Field Notes

VS1 and VS2 - RS-232 DB-9 Connection Diagram

DB-9 pin connections

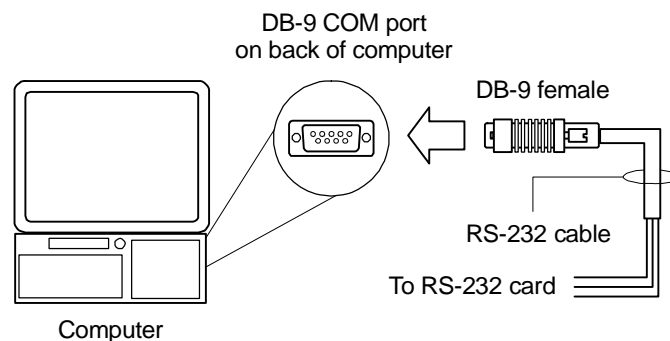
The DB-9 pin connections for an RS-232 cable are illustrated in the SA-232 installation sheet and in the VS1 and VS2 technical reference manual. These diagrams are incorrectly labeled.

The connector required is a DB-9 female, and the view should be labeled "back view."

The corrected diagrams are shown below. These will be incorporated into the next release of the installation sheet and manuals.
